PLANNING COMMISSION
Regular Meeting
Monday, April 8, 2019
6:00 PM
Christine Nuernberg Hall

Agenda

CERTIFIED SURVEY MAP NO. _____

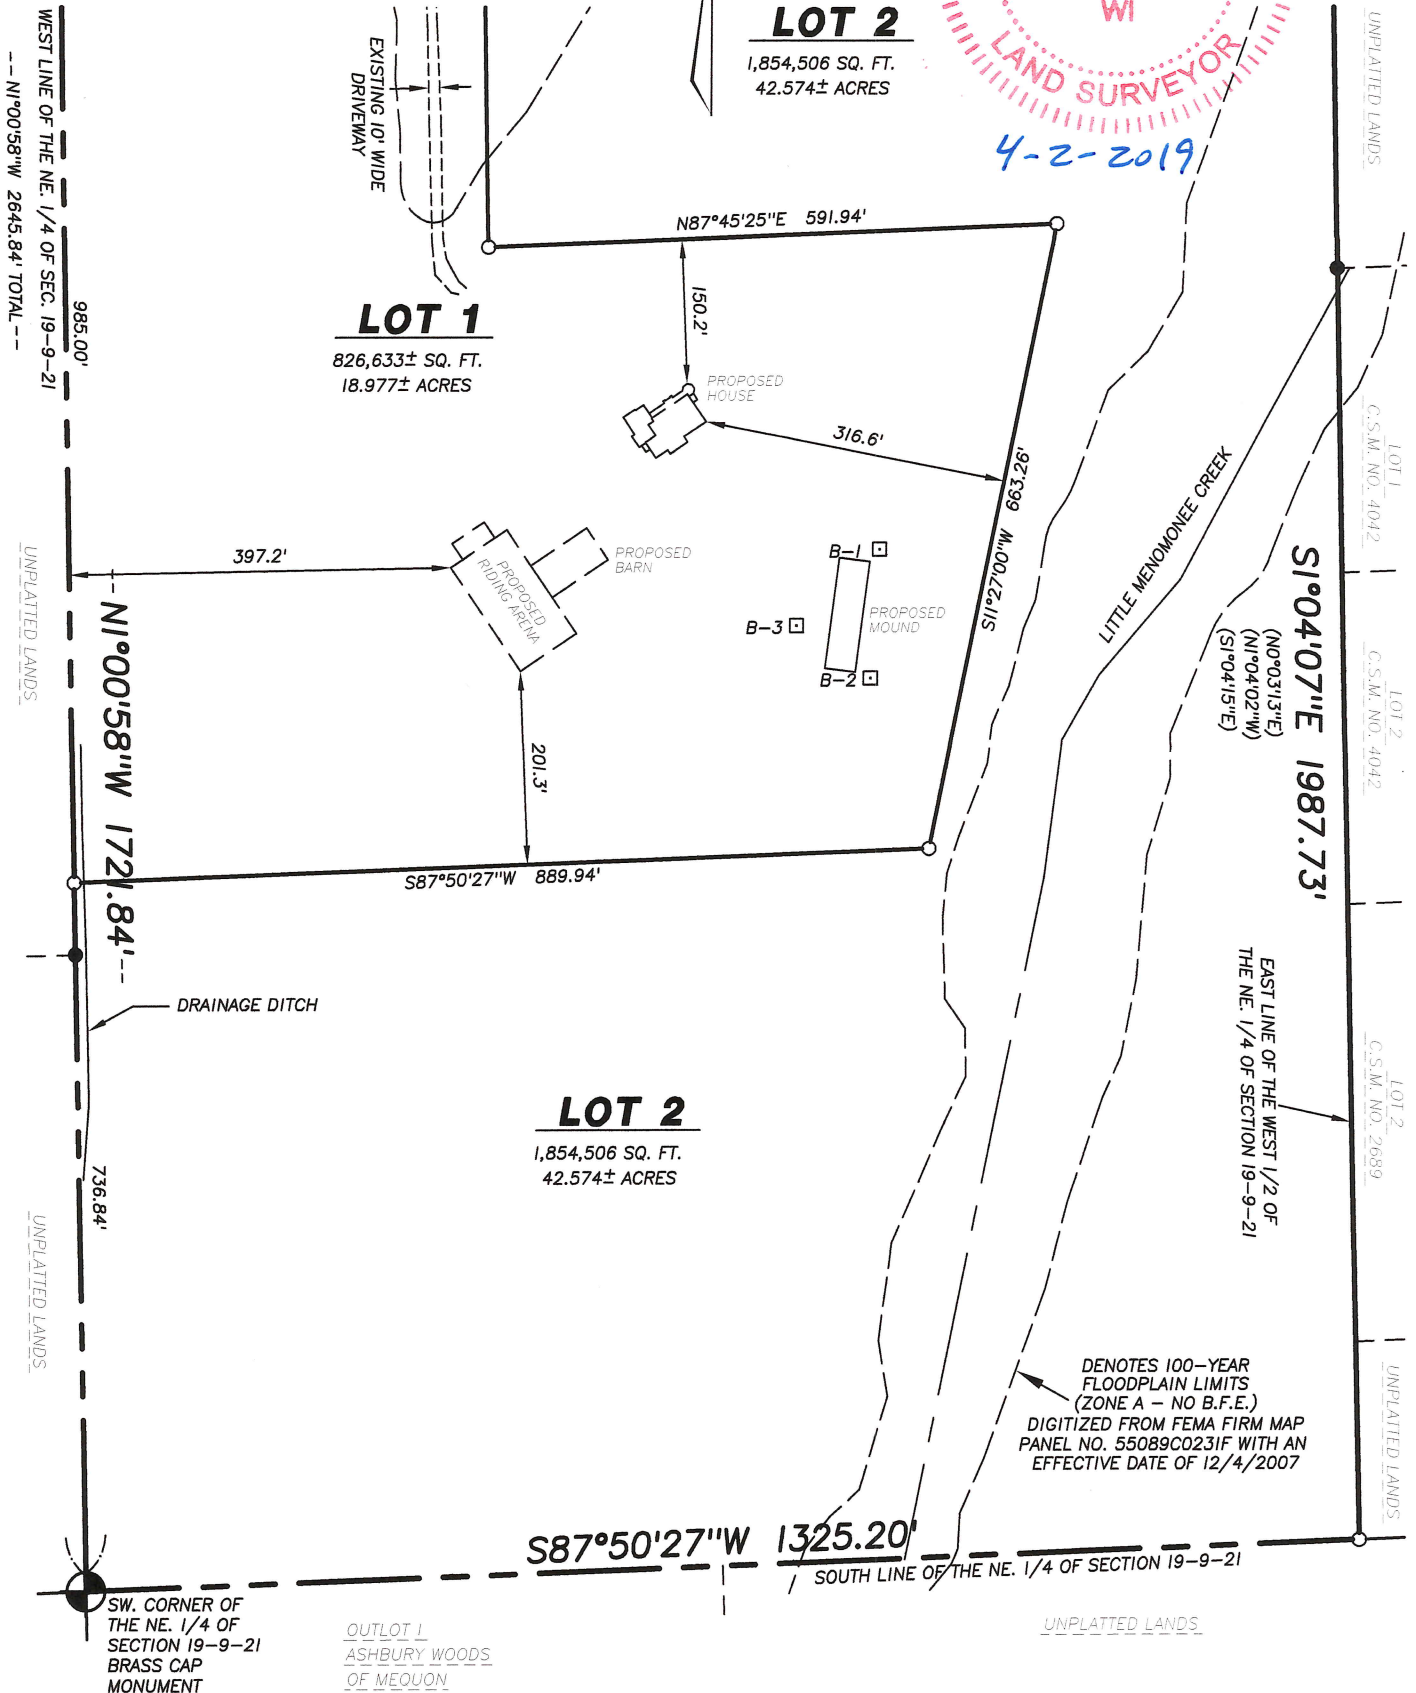
Lot 1 and Lot 2 contain frontage on Freistadt Road. The CSM includes 50-feet of right-of-way (ROW) dedication on Freistadt Road to the City of Mequon. This is consistent with the ultimate road ROW plan.

Wetlands and floodplain appear to be present on site. A wetland delineation report with concurrence by the Wisconsin Department of Natural Resources (WDNR) is required for Lot 1. The WDNR surface water data viewer and aerial photos were used to confirm that wetlands may be present. The wetland delineation for Lot 2 will be required at the time of building permit, should Lot 2 ever be developed. The CSM shall show the wetland delineation and setbacks for Lot 1 and indicate that there was no delineation completed for Lot 2.

4. The CSM shall include a deed restriction precluding access along the frontage of Lot 2 at Freistadt Road. No driveway access will be allowed to Freistadt Road to serve Lot 2 or any future divisions of Lot 2.

5. Applicant shall provide the wetland delineation report and add the wetland boundary to the face of the CSM, including applicable setbacks.
6. Applicant shall add the notation that no wetland delineation was completed for Lot 2, but one is required prior to building permit.

FLOOR PLAN
Sheet Number:
A-101A
Project Number: P
P-12389

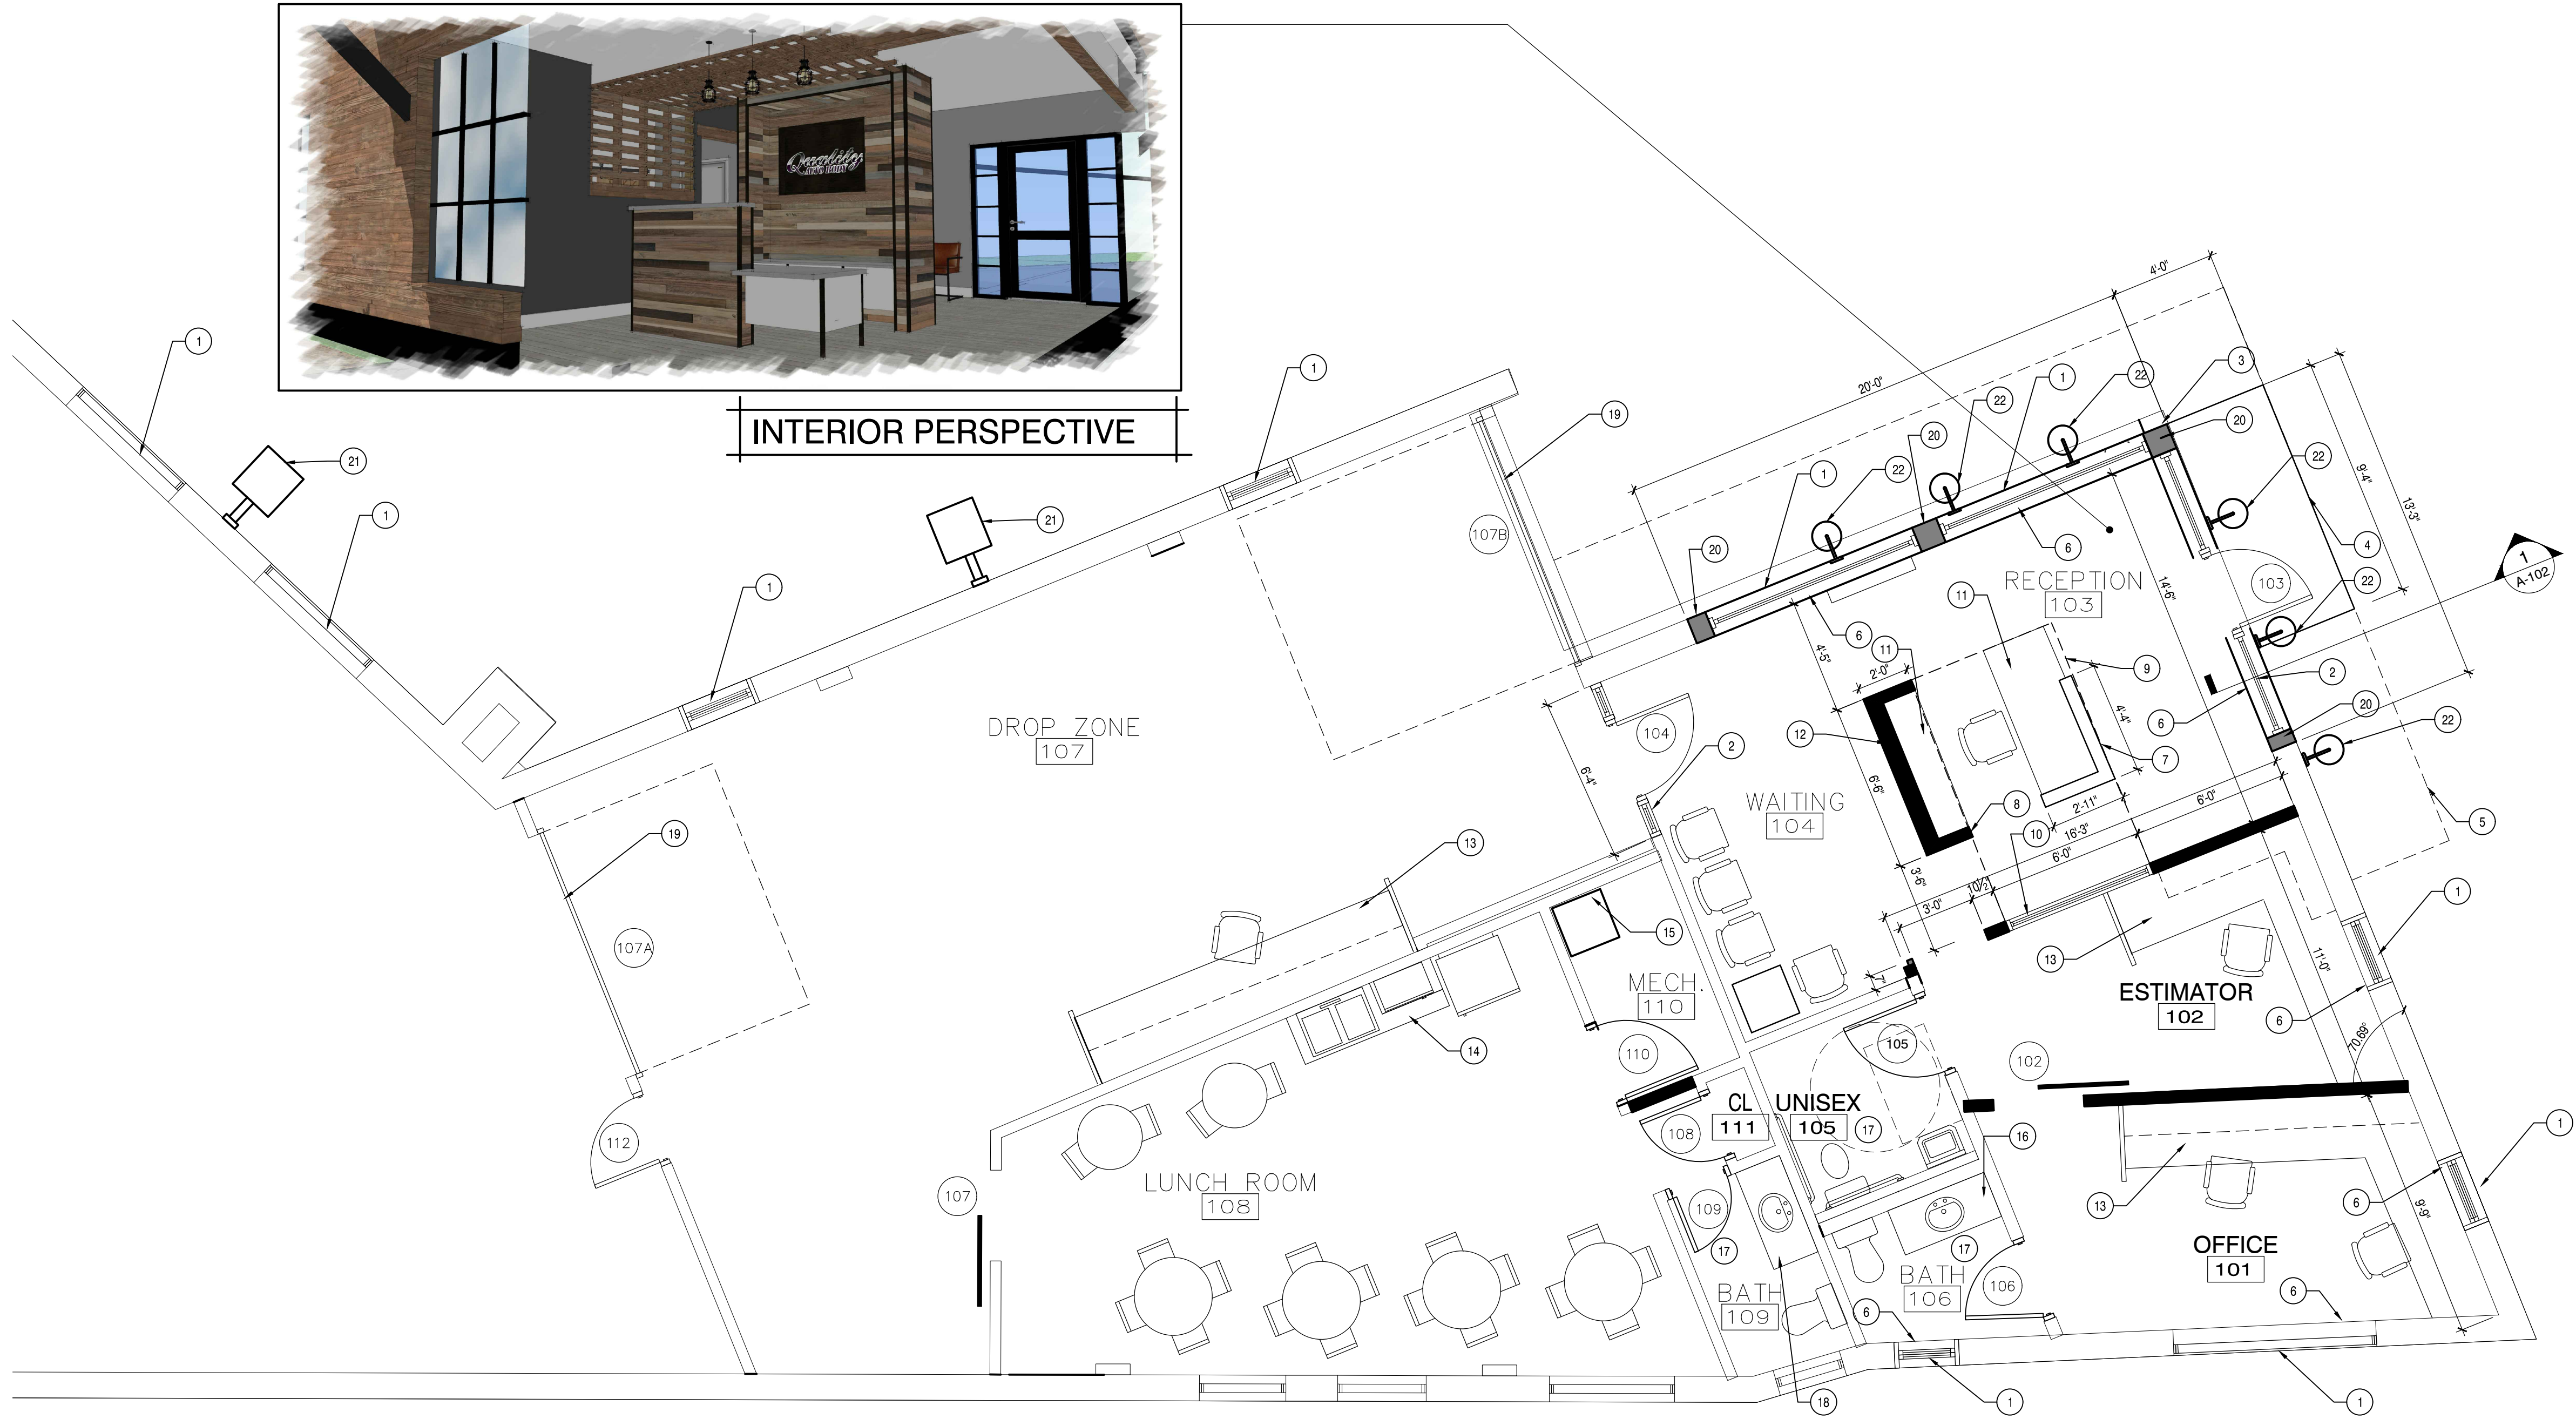
The proposed building plan design includes the addition of metal wall panels, lap siding and aluminum storefront windows. The additional windows on the east and north elevation along with the new canopy and entranceway are a vast improvement to the building design and are in line with the following goals of the Town Center:

1. Staff review and approval of final building and elevation plans.
2. No outdoor storage of junk vehicles or car parts.
